SERVICE ACTION

Reference number:	SA-01-1144	Issued: 23 November, 2018
Subject:	Incorrect Alignment of Door Latch Striker	
Model(s):	Vantage 19MY	
VIN range:	Refer to the separately published list of affected Vehicle Identification Numbers (VINs)	
Applicable to:	All Dealers	
Distribute to:	After Sales Manager Executive Manager Service Manager Sales Manager	Warranty Staff Technician(s) Parts Staff

Figure 2

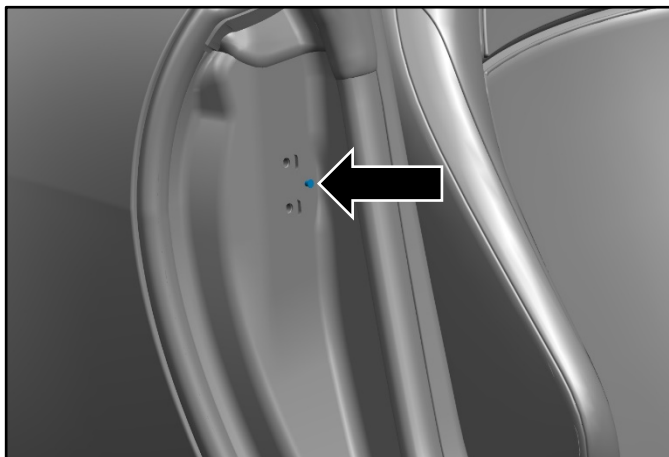
4. Visually inspect the rivet head to make sure that it is flush on the door opening panel (refer to Figure 2).

5. If the rivet head is not aligned correctly, use a punch (6mm diameter flat nose) with a mallet to align the rivet head correctly.
6. Install the door striker (refer to Workshop Manual Procedure 01.14.CA for the right side door striker or 01.14.CB for the left side door striker).
7. Do a check to make sure that the door closes correctly. Adjust the door if necessary.
